## MEJQ-20 Locating Pin Hole Position and Counterbore Depth Change

**MEJQ-20**

Before		
After

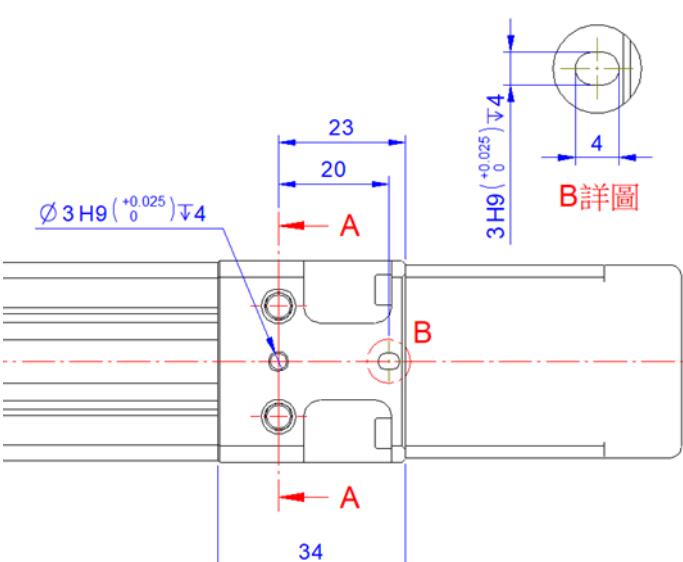
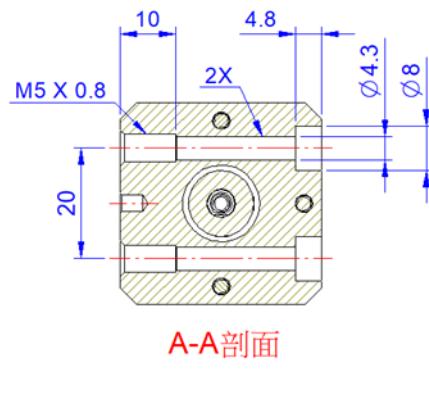
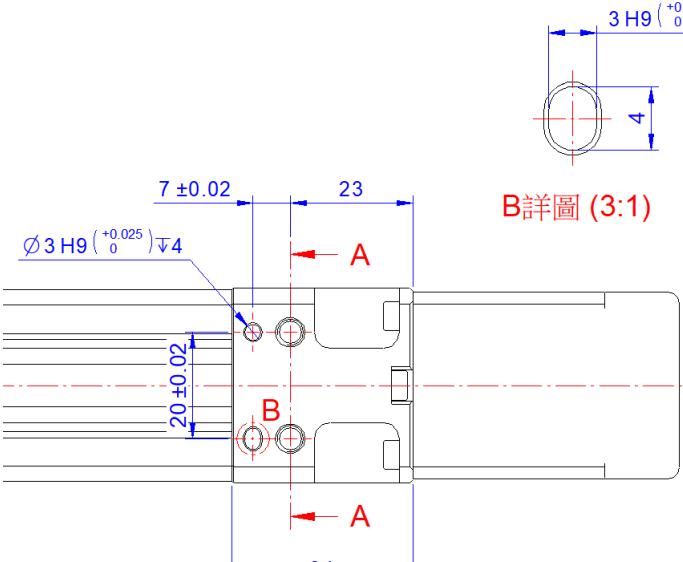
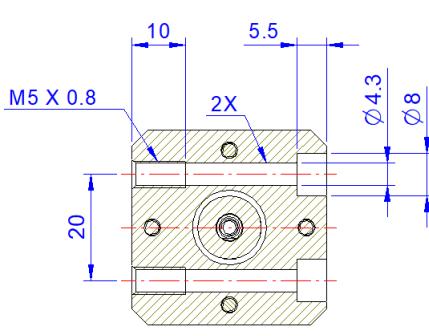
**To enhance product stability and respond to market feedback, an additional tightening bolt has been added to the motor mounting bracket, and the position of the locating pin holes have been changed, along with an increased depth of the counterbore.**
